CCK-2568-22

ADDENDUM # 4

CONSTRUCT/ IMPROVE GREEK HOUSING (DELTA GAMMA) Bid Package #2 – All Work Categories

UNIVERSITY OF KENTUCKY
 2555.0 Construct/Improve Greek Housing
 (Delta Gamma House)

HARDSCAPE DETAILS

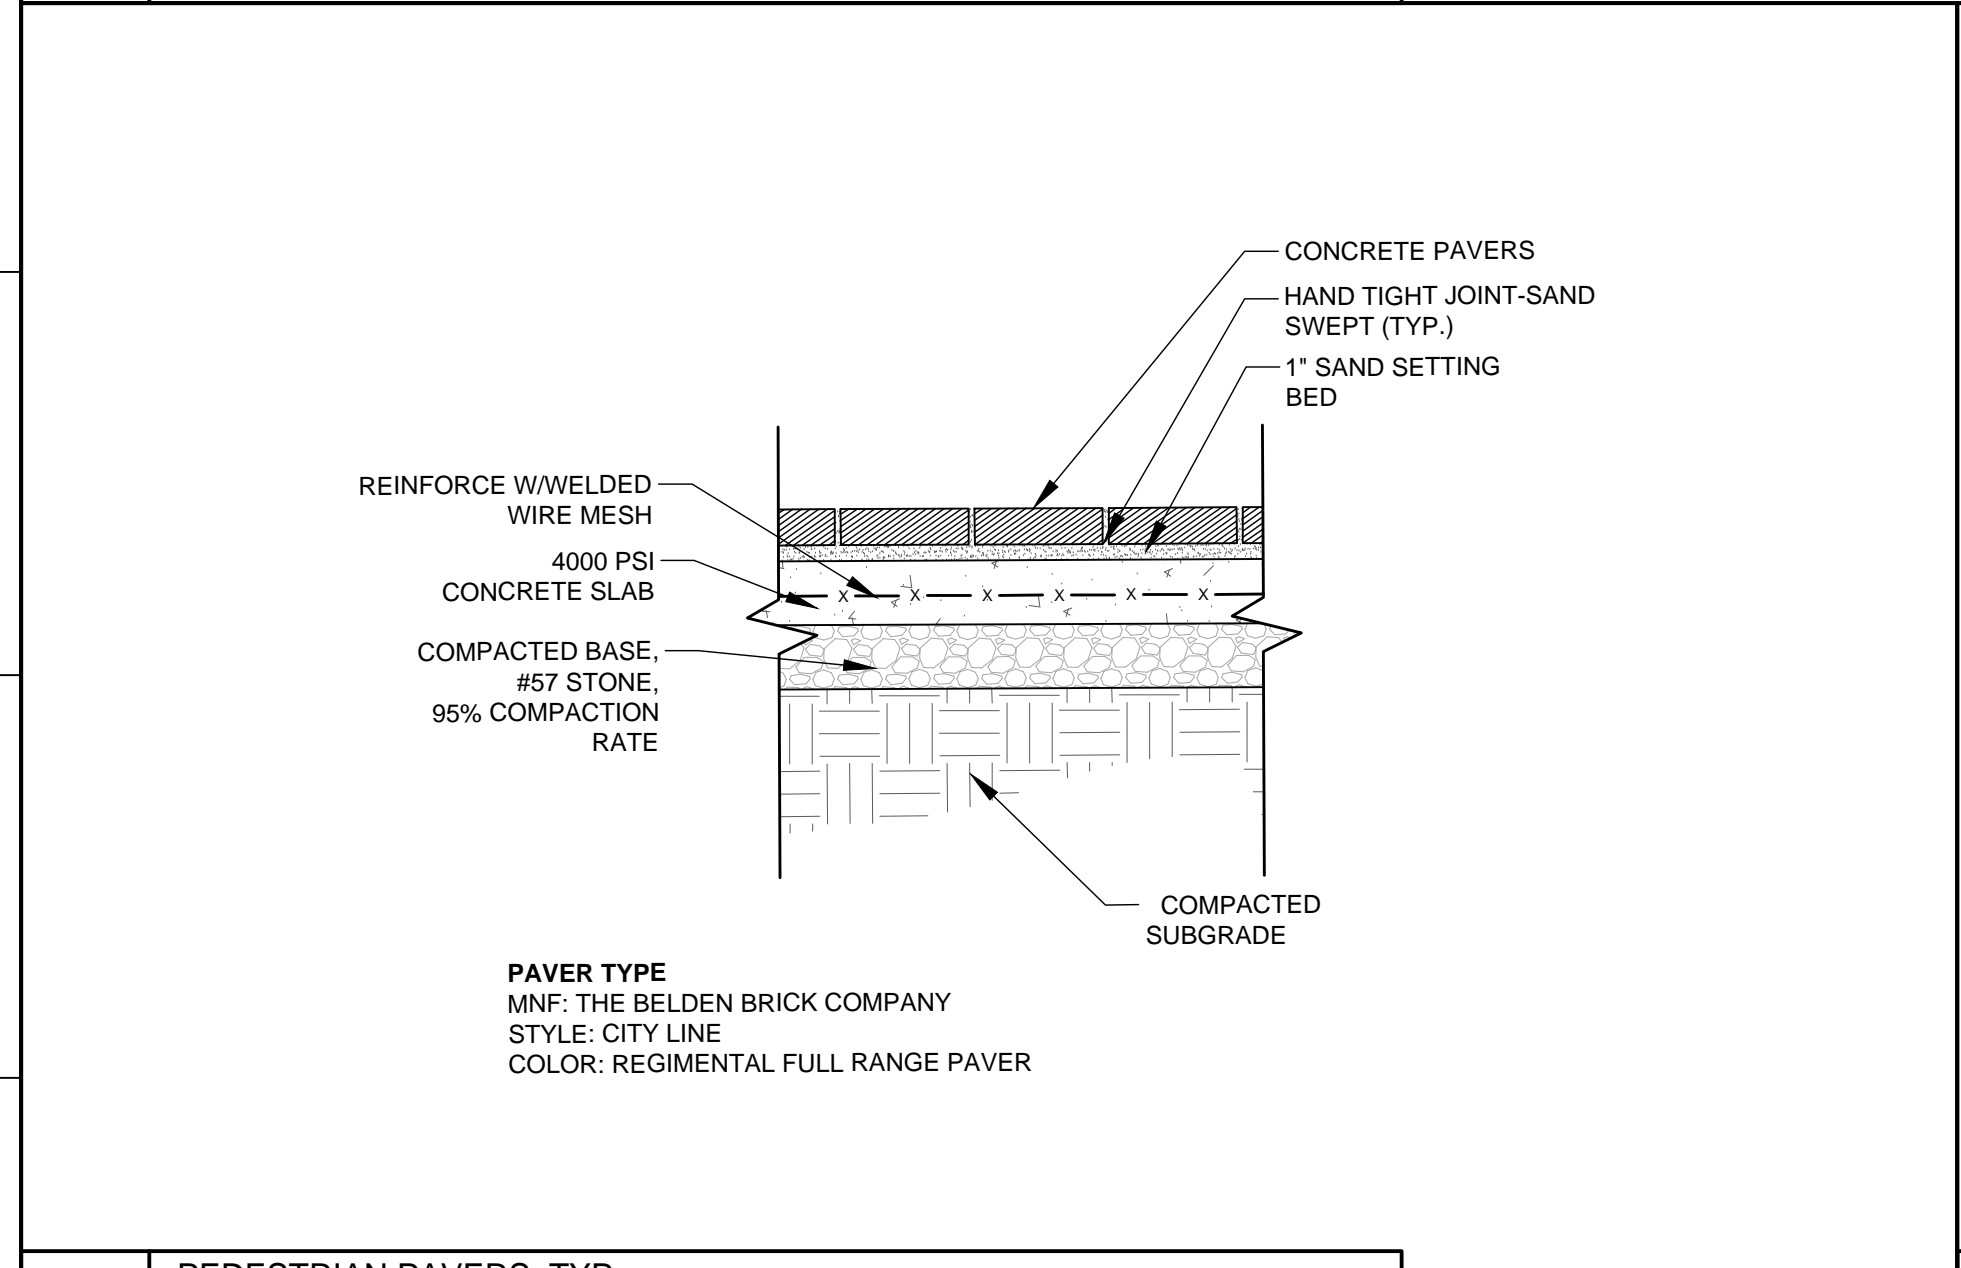
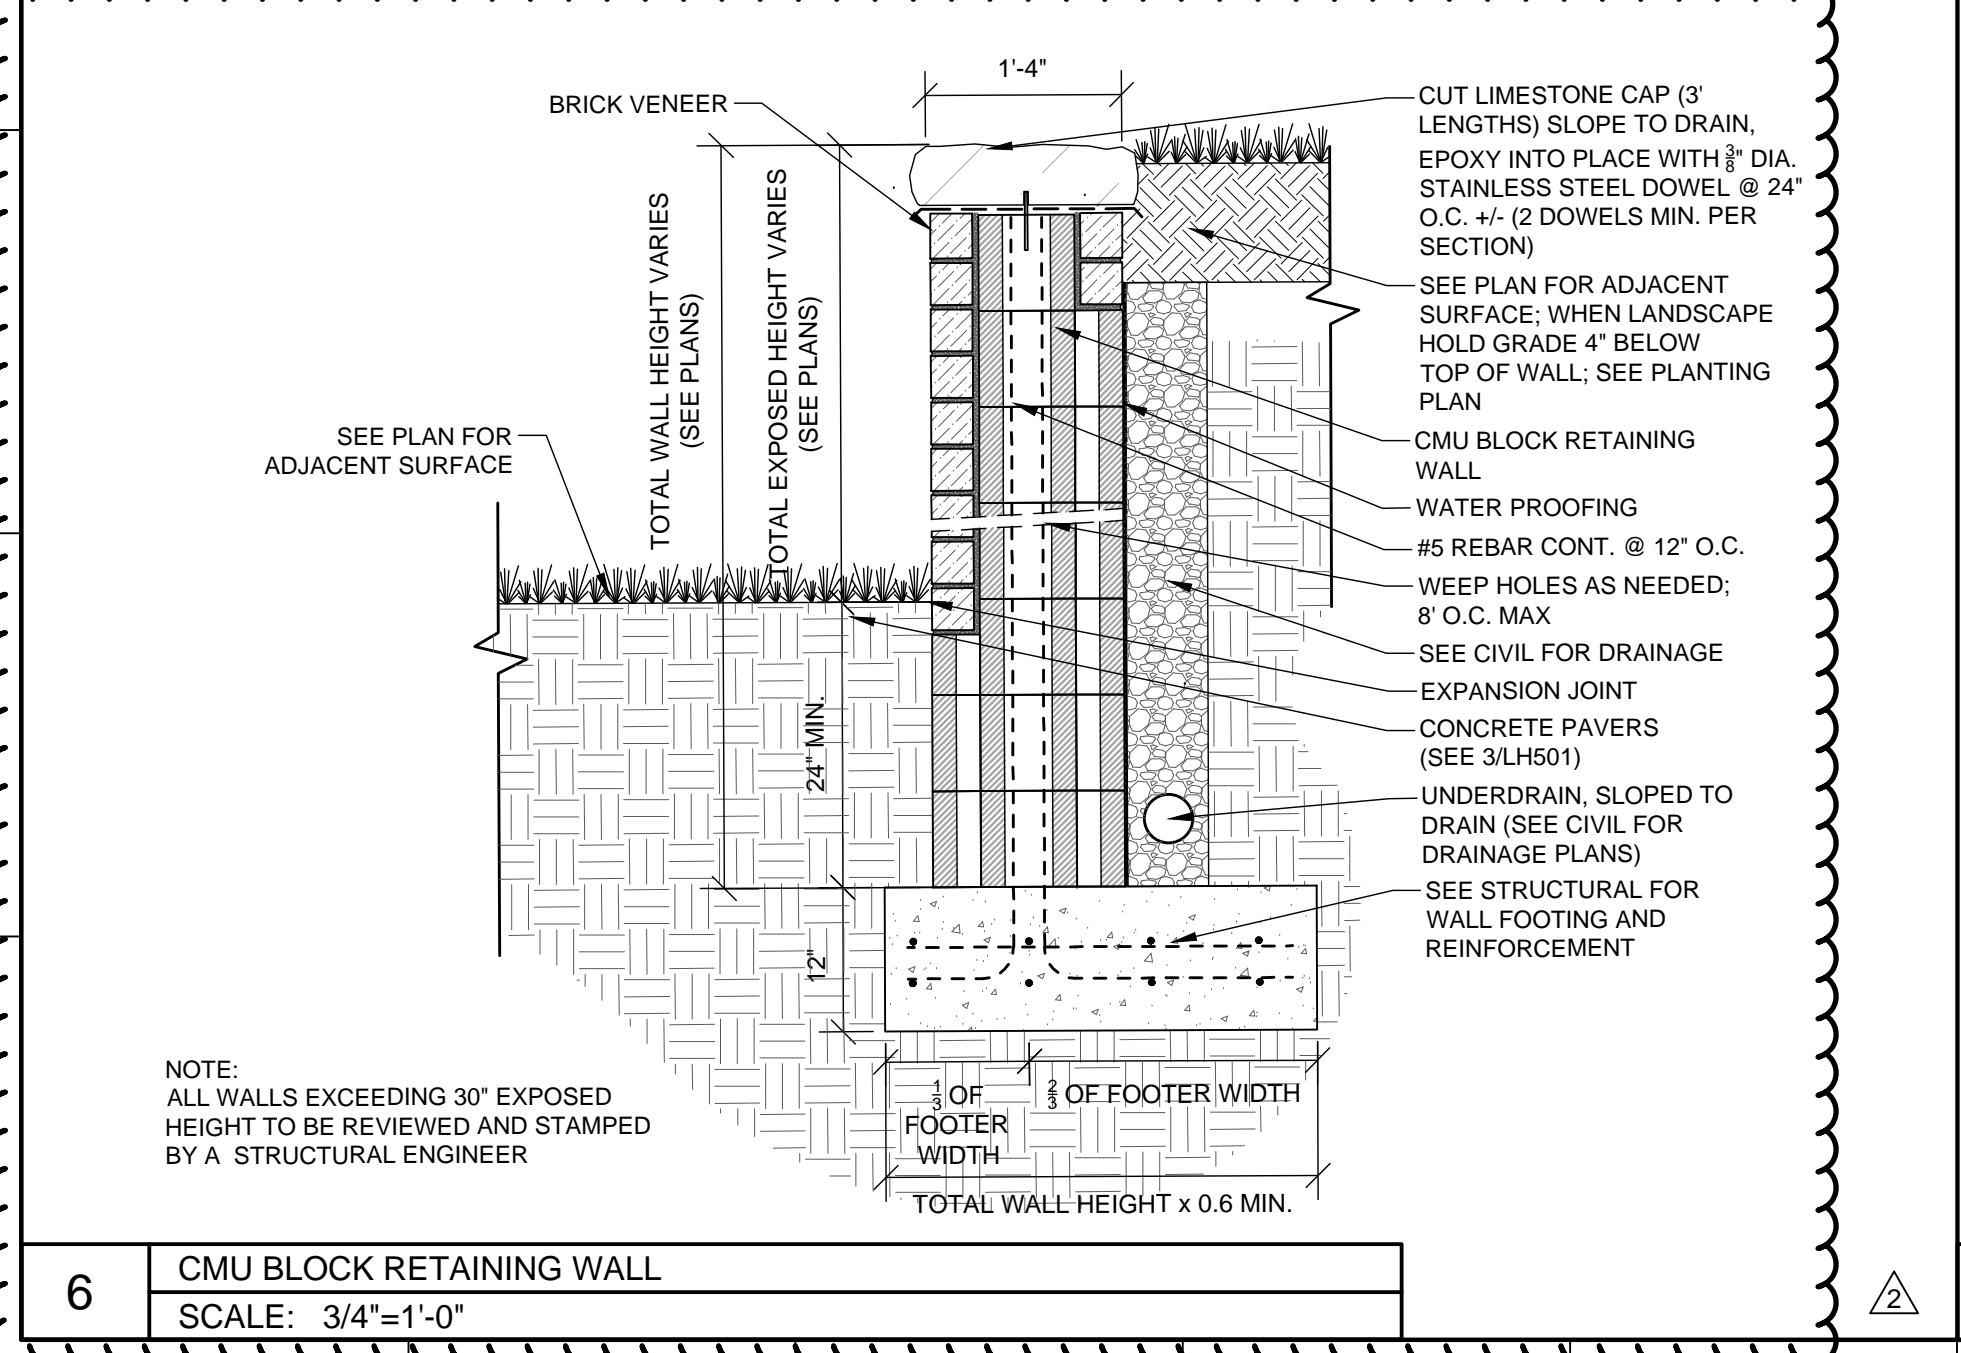
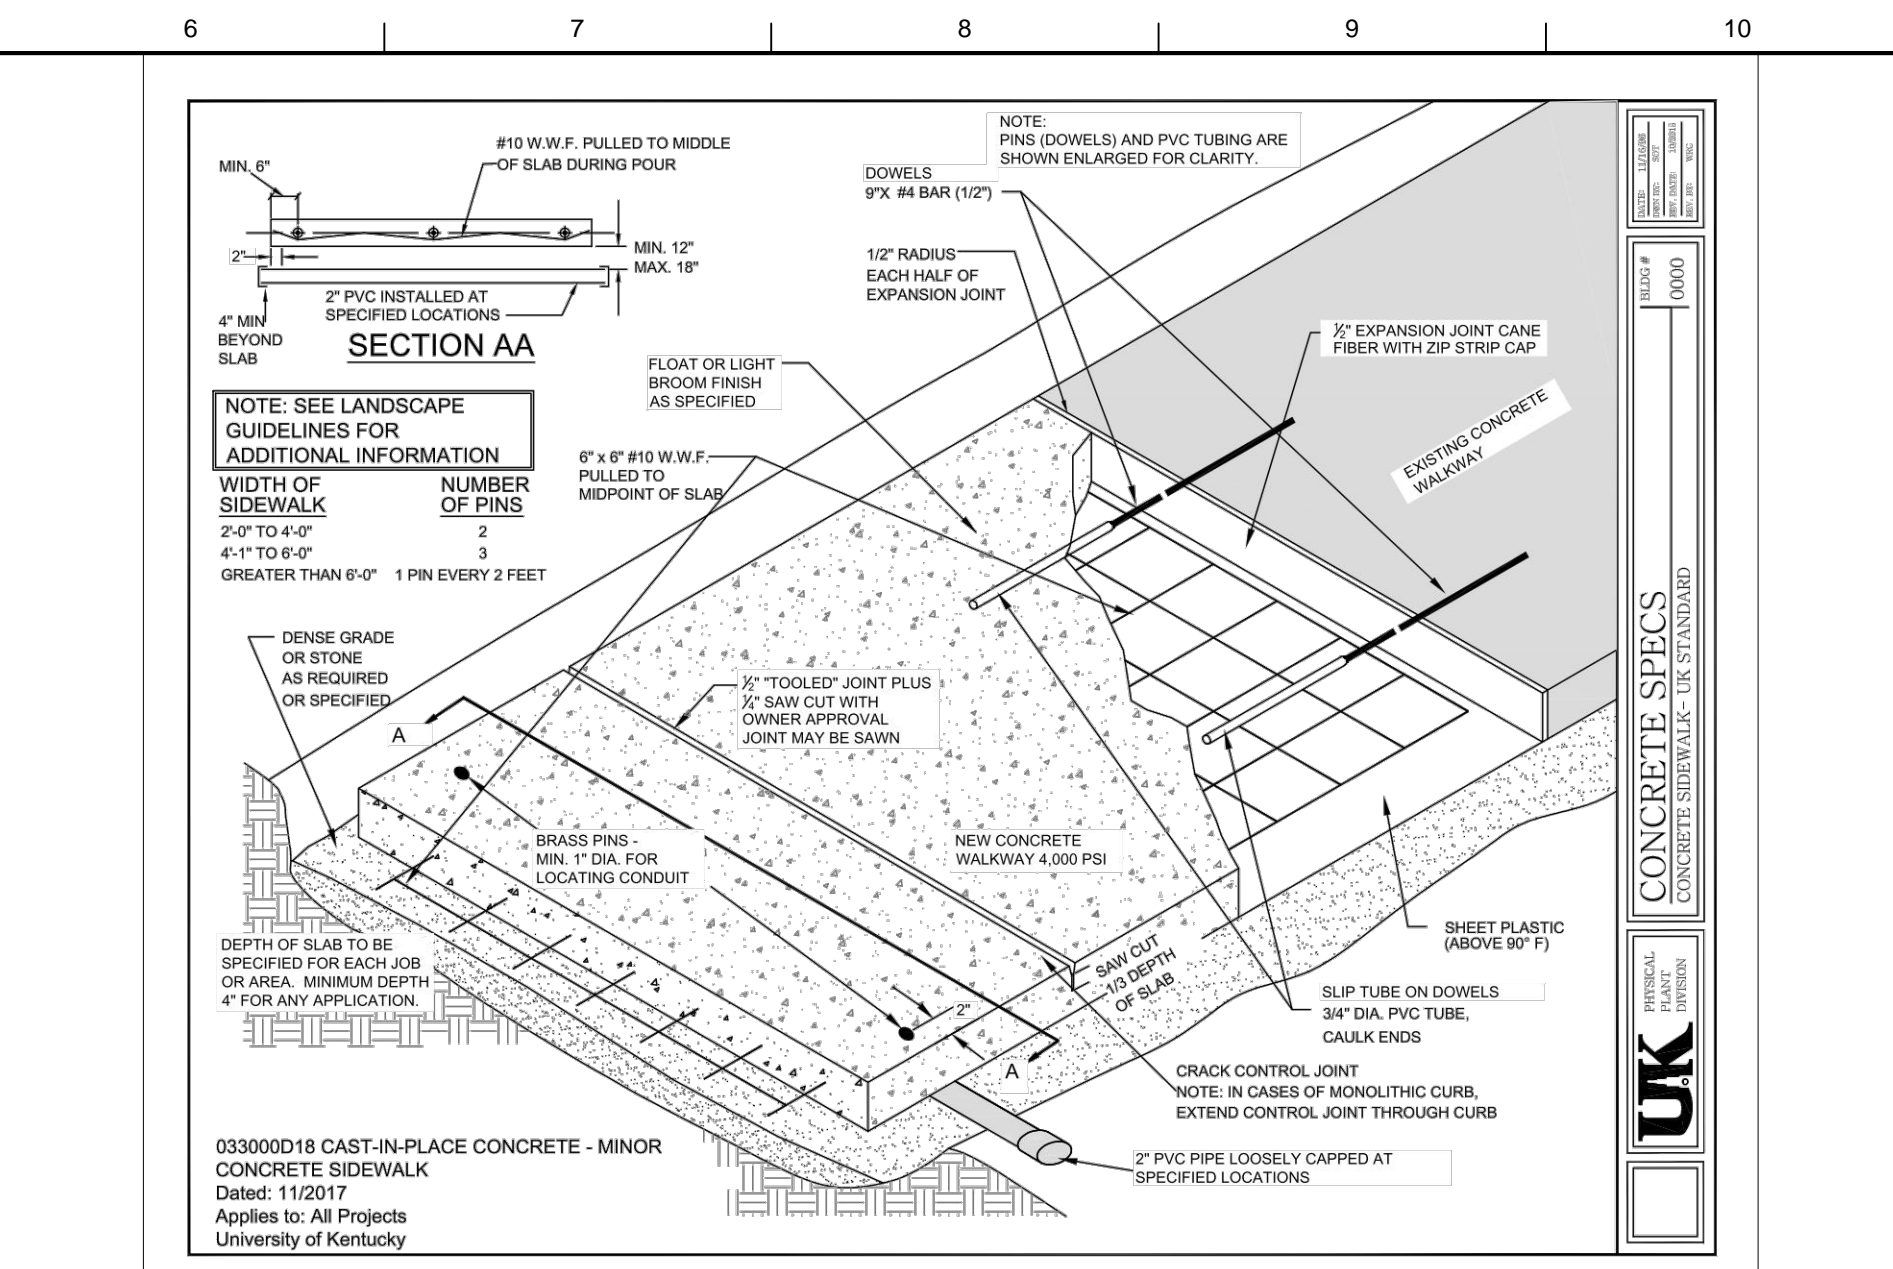
LH501	HARDSCAPE DETAILS	9/7/21
	<ul style="list-style-type: none"> • Wall detail labels and footings revised 	
LH502	HARDSCAPE DETAILS	9/7/21
	<ul style="list-style-type: none"> • Wall detail labels and footings revised 	
LH503	HARDSCAPE DETAILS	9/7/21
	<ul style="list-style-type: none"> • Wall detail labels and footings revised
